INSTRUCTION TO SERVICE

ITS: 5000	
SECTION:	260 Battery Compartment
WRITTEN BY:	Mike Pearson
SUBJECT:	Rework BAE Energy Storage System Covers

Figure 1: Hinged Door Installed Correctly

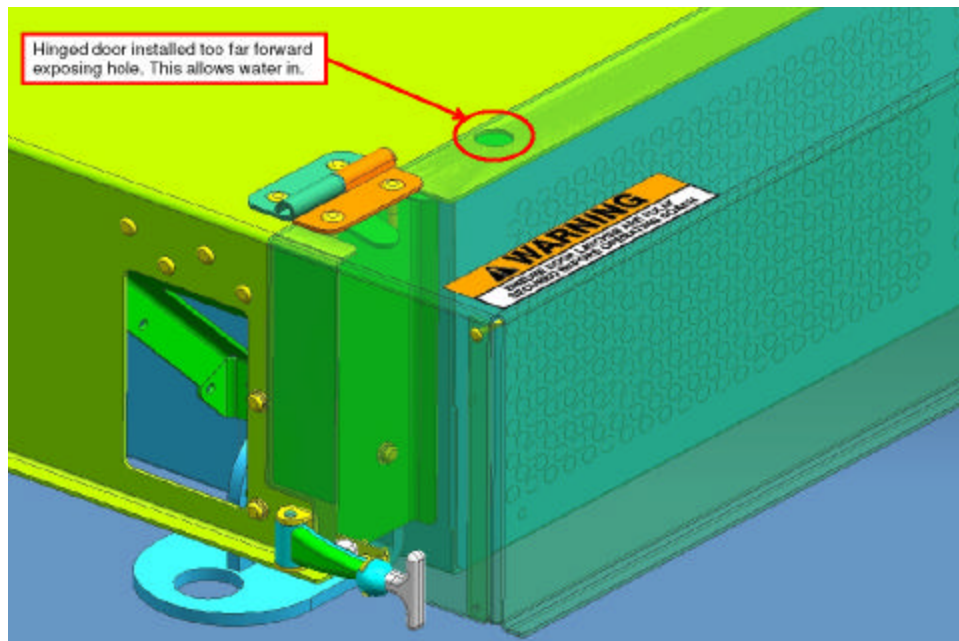
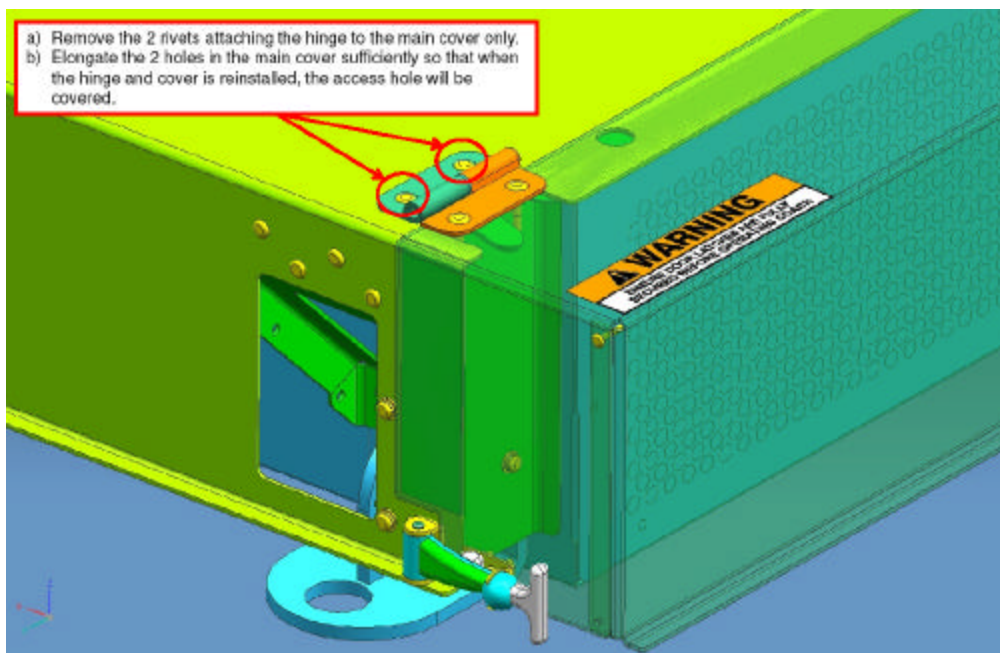
1. Turn the main battery disconnect switch to the “OFF” position.
2. Follow as per appendix A: Equipment and Personnel Protection.
3. Using approved fall safety protection equipment inspect BAE ESS covers for as follows:
 - a. Hinged filter door installed too far forward exposing the access hole for the filter as shown See Figure 1.

1. If any of the of the filter access hole is exposed rework as follows,

Figure 2: Misalignment of Cover mounting holes

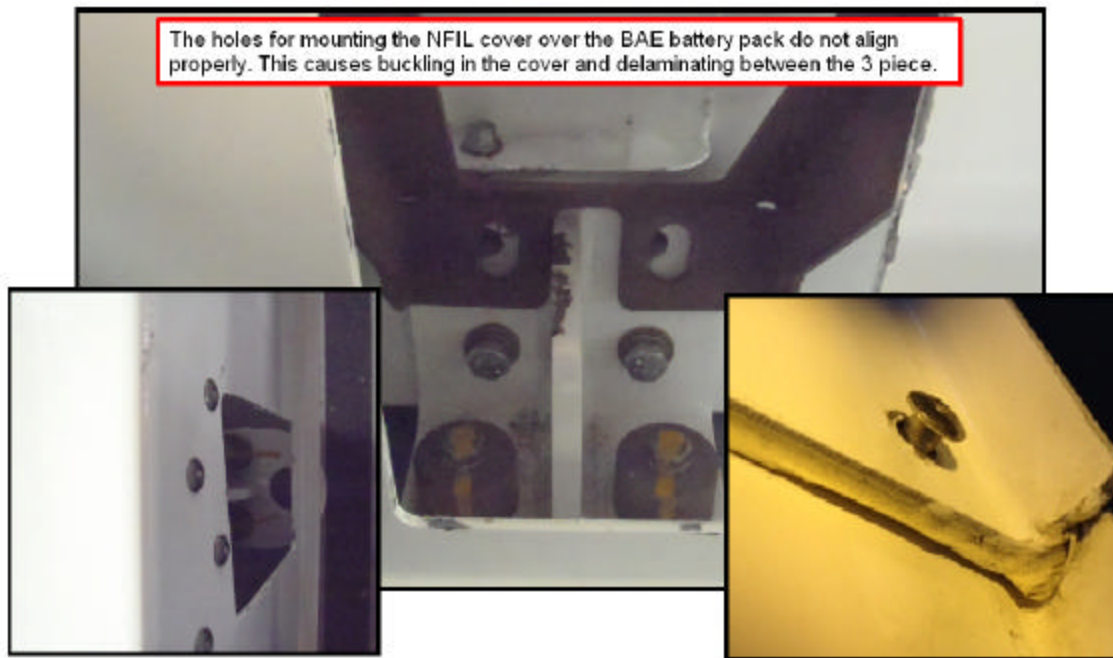
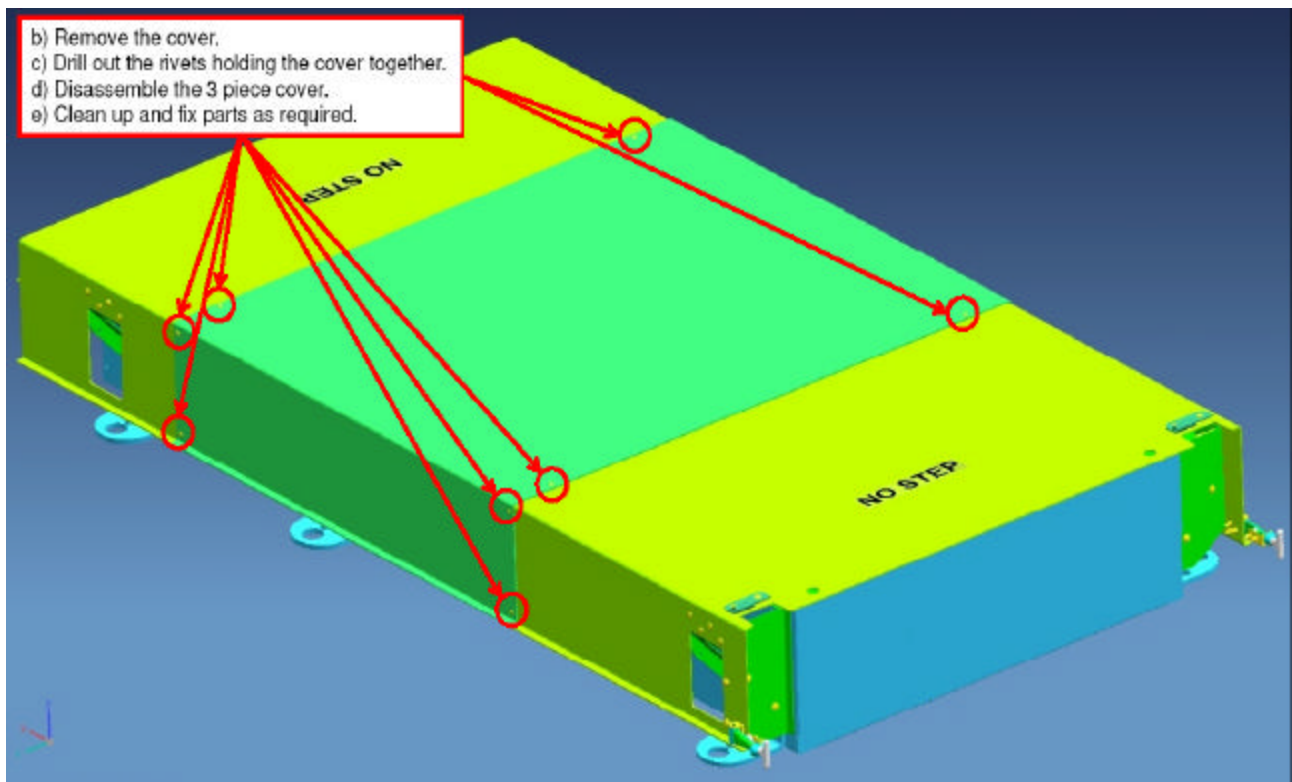
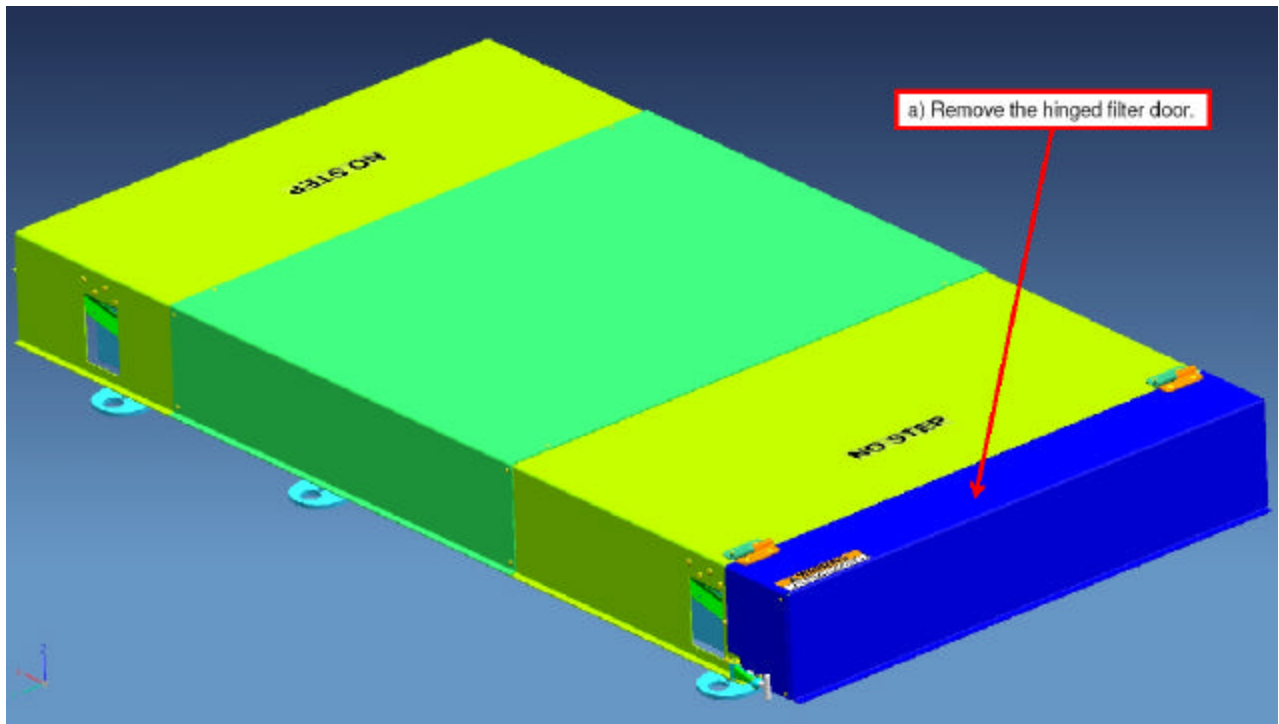
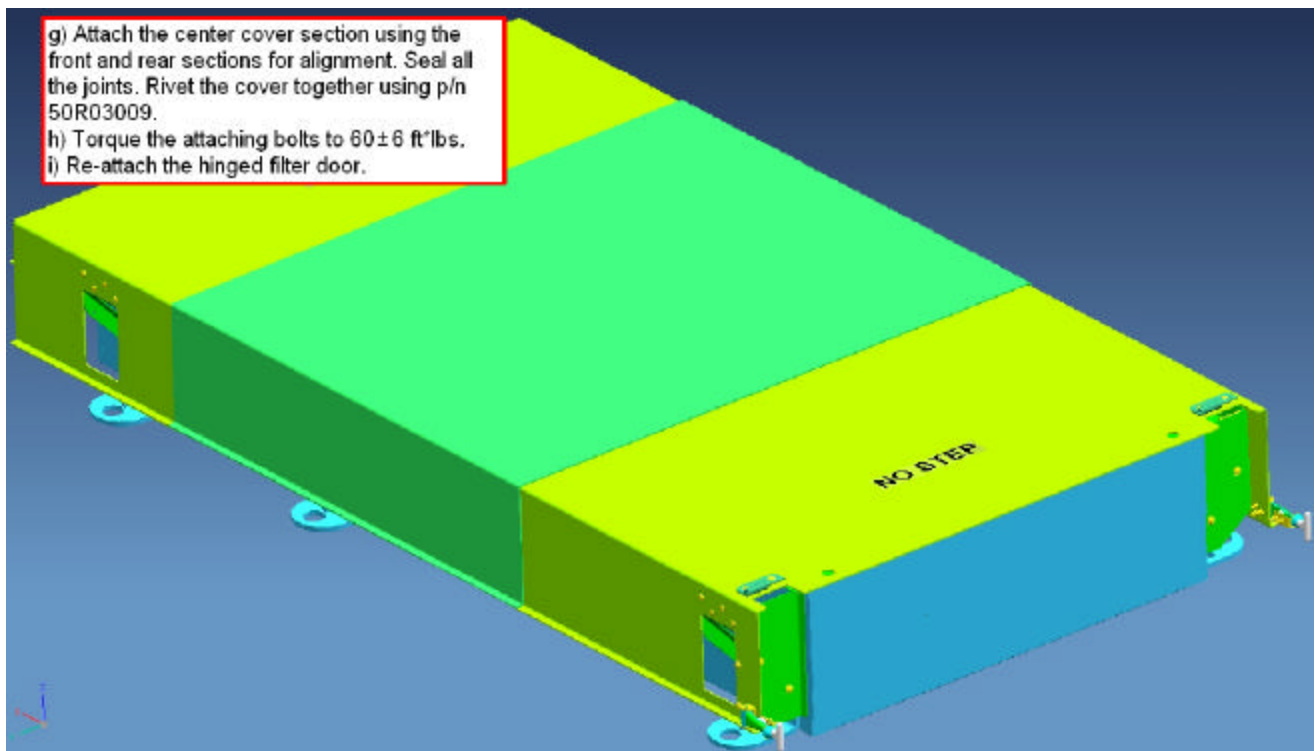
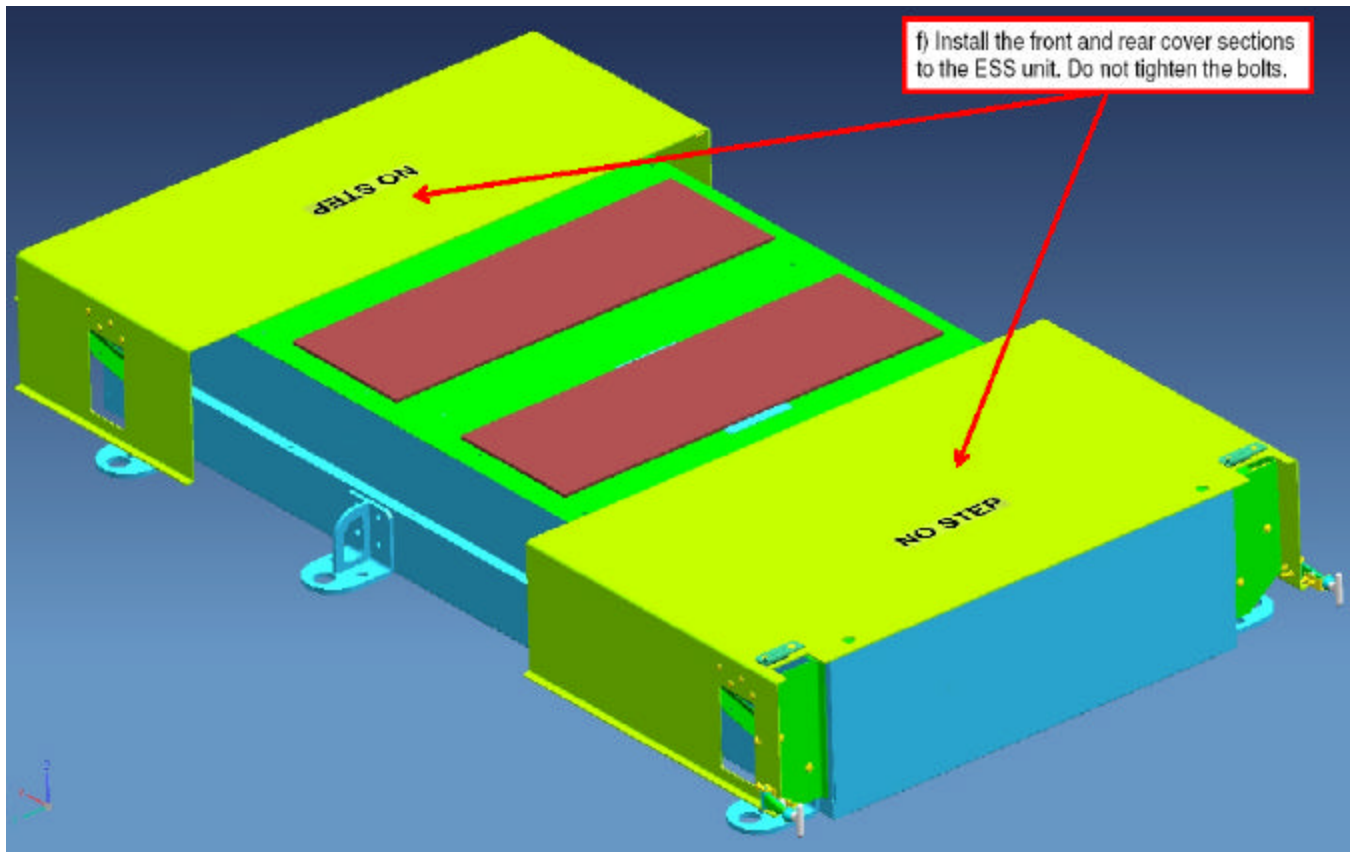
- b. Buckling in the 3 piece cover and delaminating between the cover pieces as Shown in Figure 2.

1. If the holes for mounting the NFIL cover over the BAE battery pack do not align properly rework as follows,
